PETITIONER'S APPLICATION - ARLINGTON HEIGHTS PLAN COMMISSION

Project Name Arlington Ale House

Project Location 111 W. Campbell St, Unit # 301

REVIEW ROUND 1

Restaurant Design Requirements

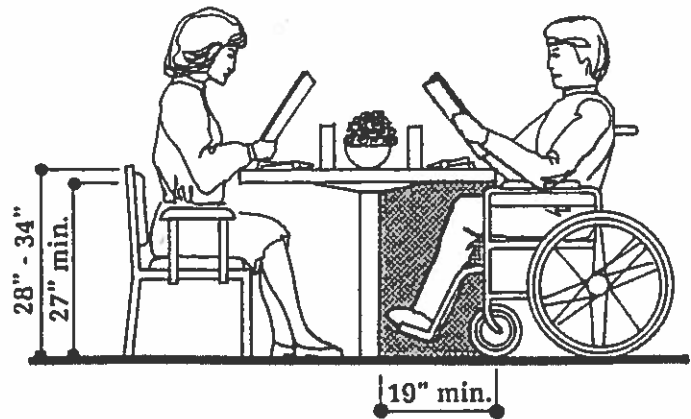
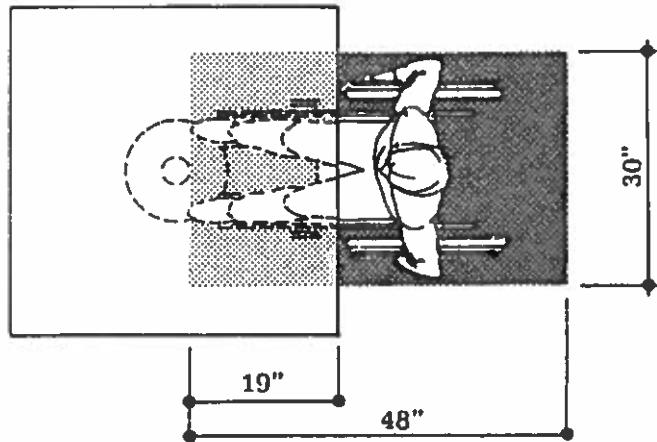
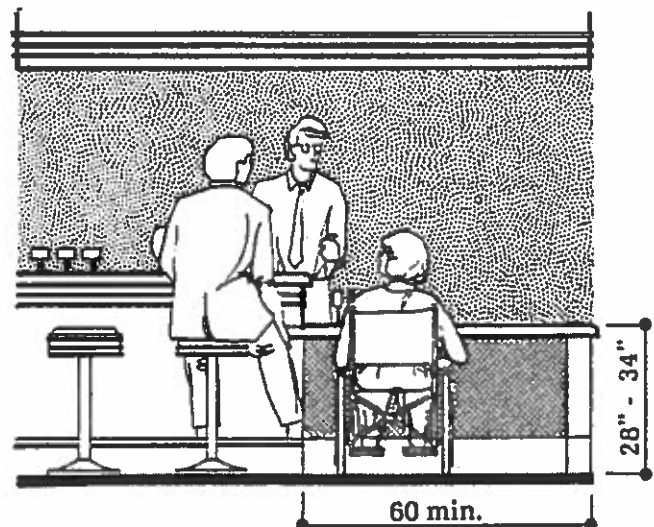
1. Dining Counter and Bar

Counters and Bars. Where food and drink is served at counters and bars exceeding 34 inches in height for consumption by customers, a portion of the main counter and bar measuring a minimum 60 inches in length shall be provided in compliance with Section 400310(w) or service shall be provided at accessible tables in the same area. IAC Sec. 400.320(L)(2).

- A. At least 27 inches high measured from the floor to the bottom edge of the table, bar or counter.
- B. At least 30 inches wide, measured between table legs or table supports
- C. At least 19 inches deep, measured from the table edge to the table leg or table support. And
- D. Table top heights of 28 to 34 inches high.
See IAC Sections 400.320(l)(1 and 2) and 400.310(w)(1-4).
